To	Cindy Luxhoj, City of Wilsonville
From	Jennifer Arnold, Emerio Design
CC:	Amy Pepper, City of Wilsonville
Date	October 17, 2023
Subject	DB23-0012 Canyon Creek South Site Design Review of Tract A – Incompleteness Letter Response

Items listed in the October 5, 2023, incompleteness letter will appear in *italics*, followed by the applicant’s responses in regular typeface.

Exhibit D: Proposed Plat Showing Easements

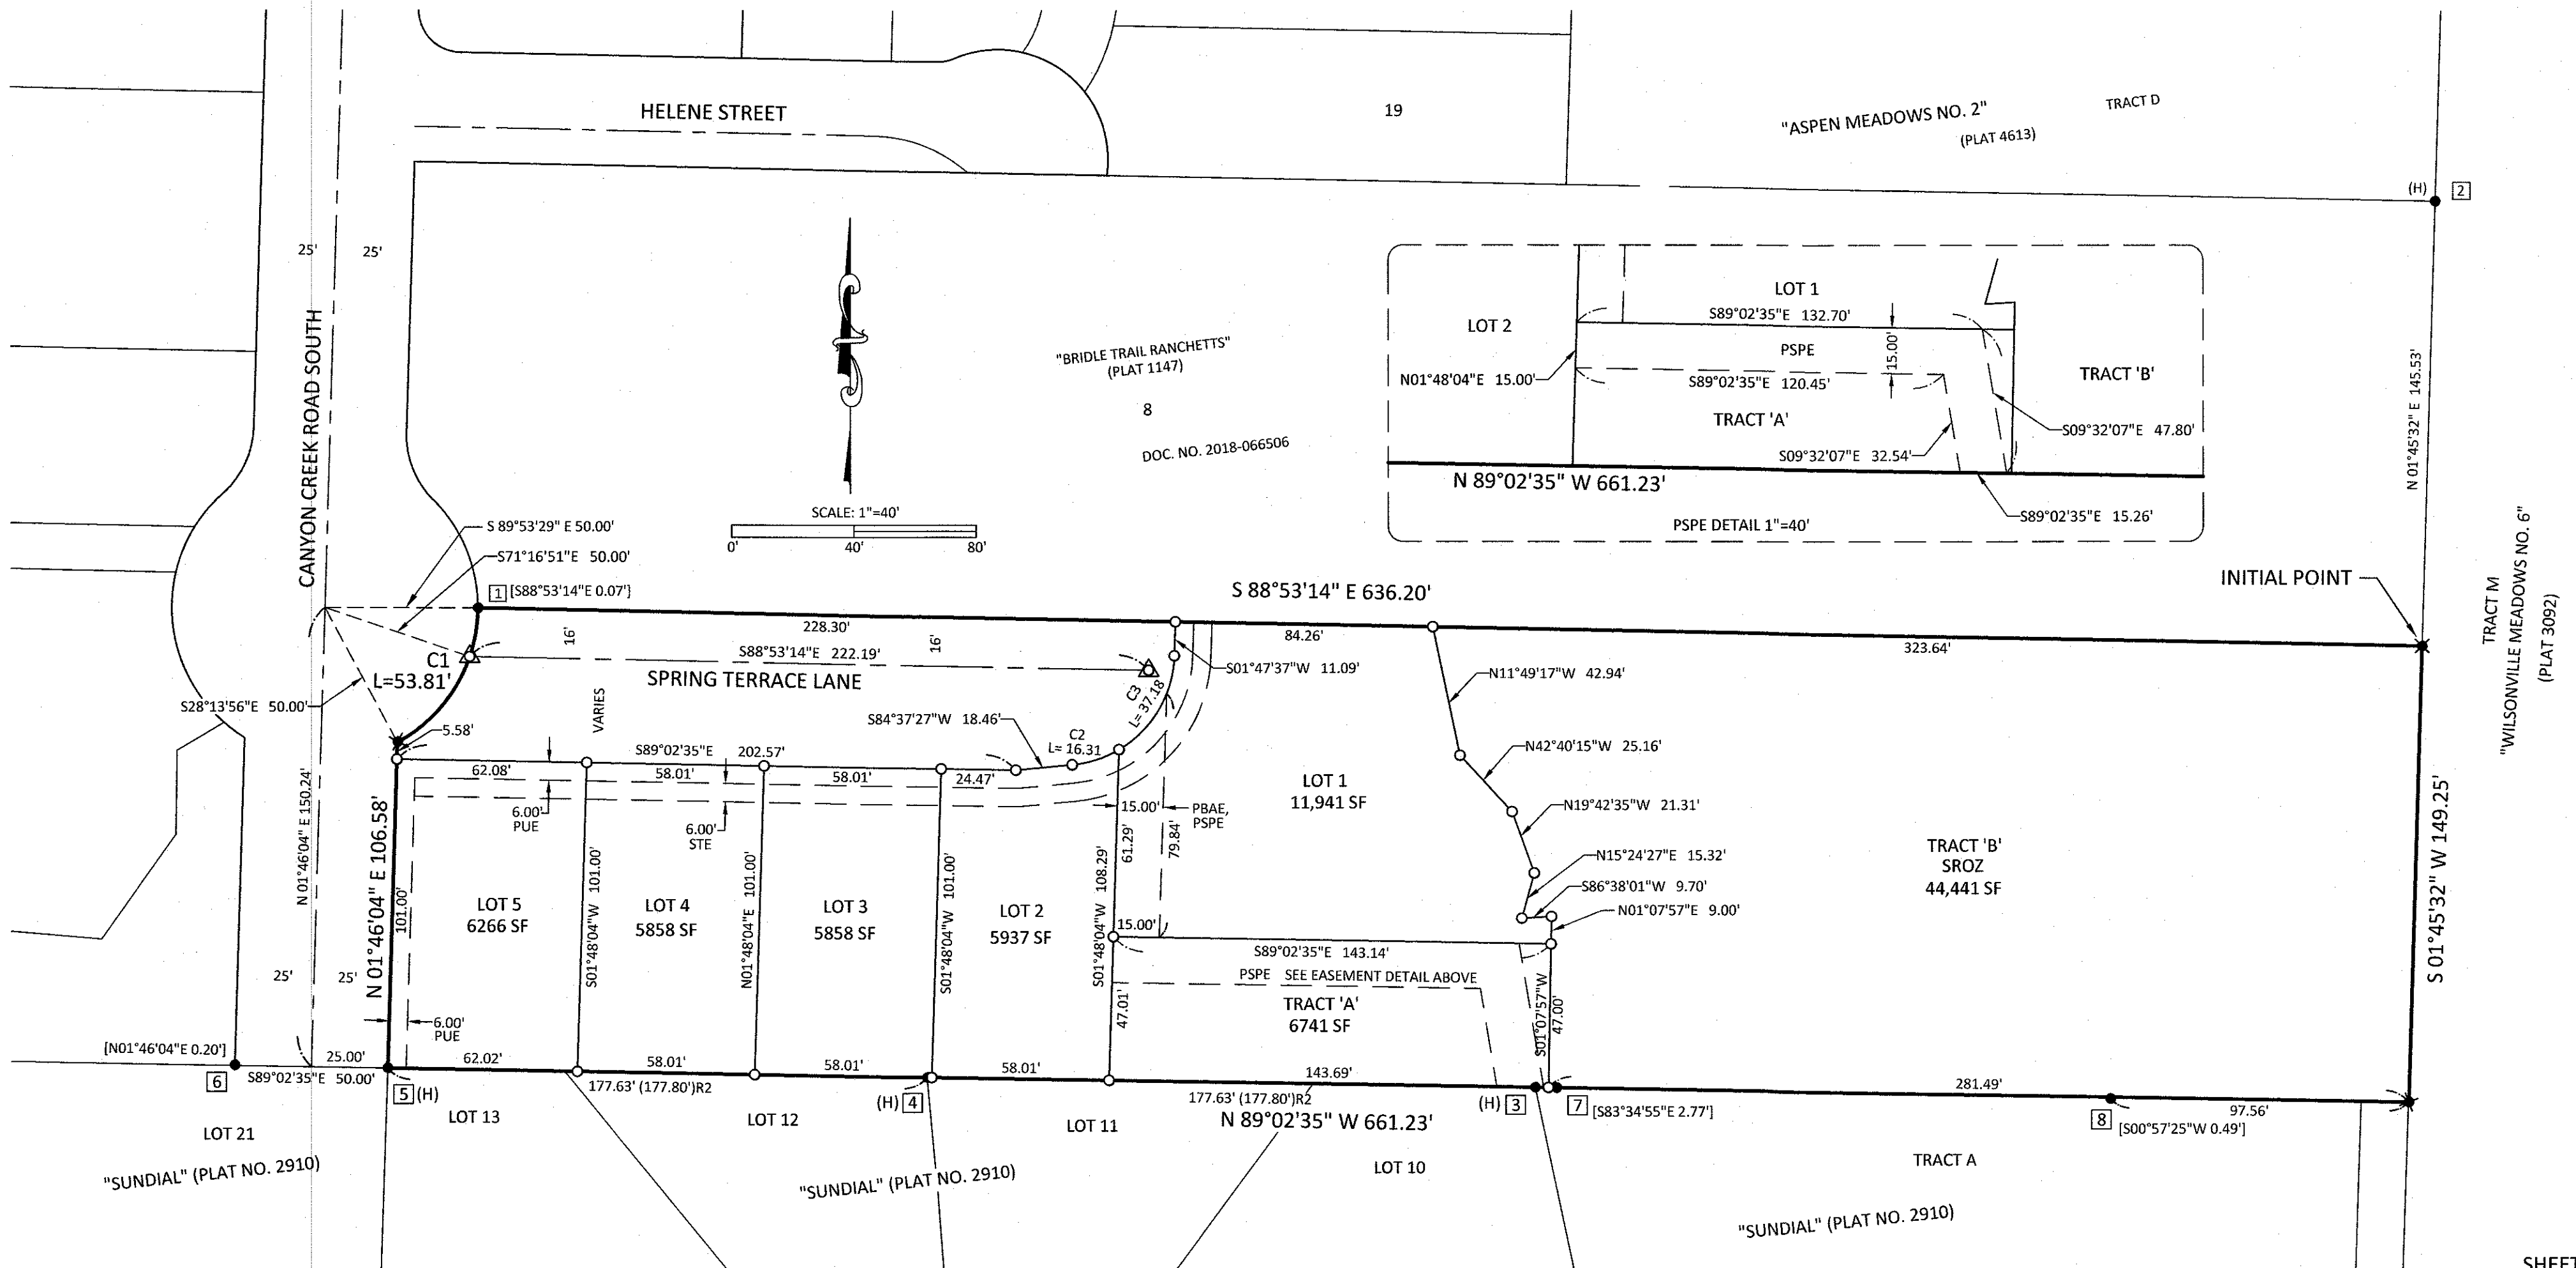
8. *Sufficient information provided about easements and dedications. Show the stormwater pipeline easement, public pedestrian and bicycles access easement, tree protection and preservation easement, and stormwater maintenance and access easements on the plans. No trees should be planted in the stormwater pipeline easement.*

Applicant Response: No trees are proposed to be planted within the stormwater pipeline easement as shown on the landscape plan. The stormwater pipeline easement is shown on the submitted grading plan and included in Exhibit D. Exhibit D also includes the plat with all easements noted and the SROZ boundary as shown on the preliminary plat. Tract A is intended to be a public space with easements to provide legal access and use.

FENCE DETAIL

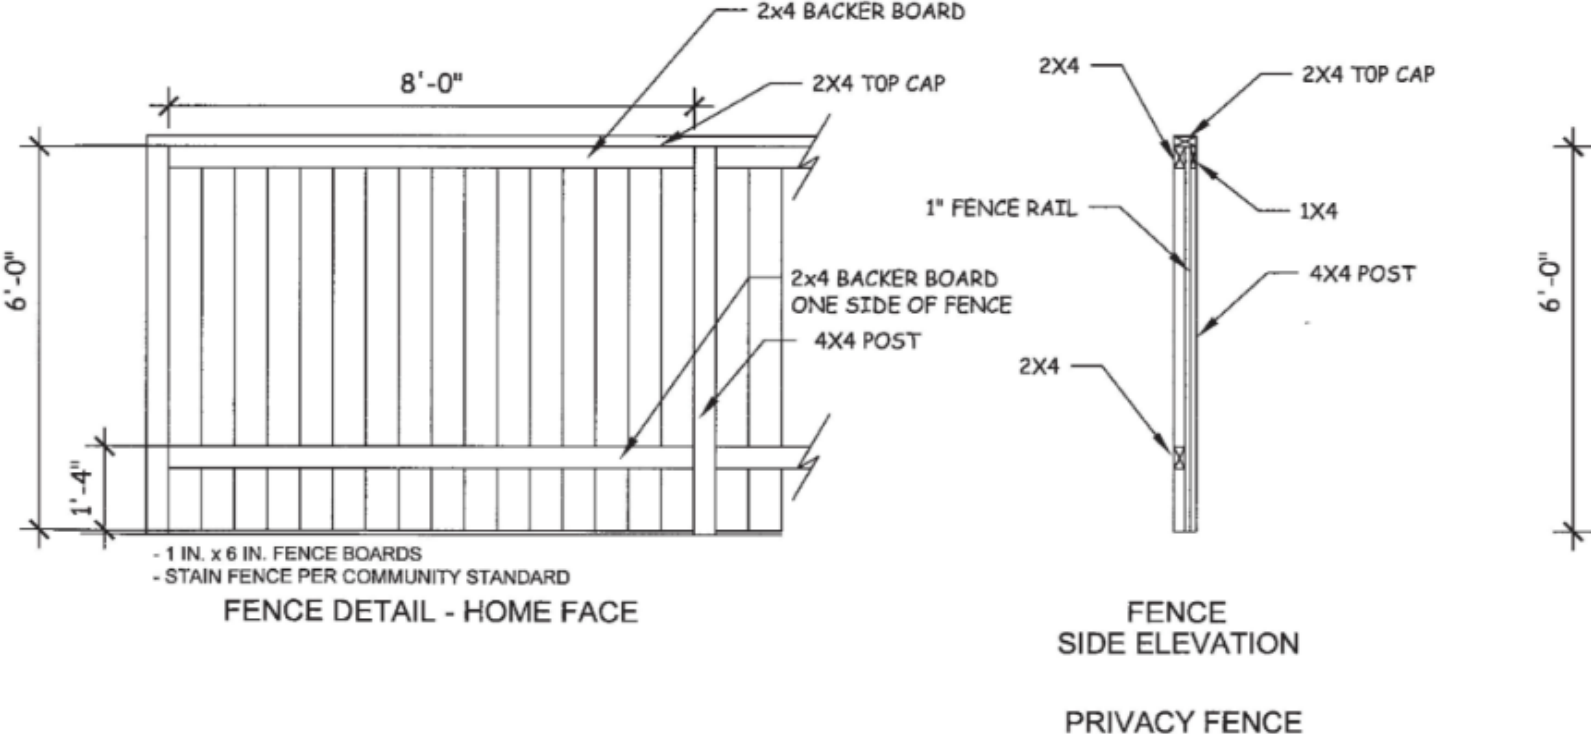
4. *Materials detail or cut sheet of the perimeter/privacy fencing, indication of where the fence will be located around the open space, and explanation of why this is necessary.*

Applicant Response: See Exhibit F for fence detail information. The applicant has proposed constructing a fence along a portion of the southern boundary of Tract A to benefit the property owners on TL1100. The existing neighbor on TL 1200 has an existing wooden privacy fence and the applicant does not propose any change to that existing fence. This will create a continuous fence along the southern boundary of Tract A which will provide safety and privacy screening. This was not an agreement made based on a requirement of the Wilsonville Development Code but out of a good faith effort to work with the adjacent property owners given the ongoing disturbance associated with construction.
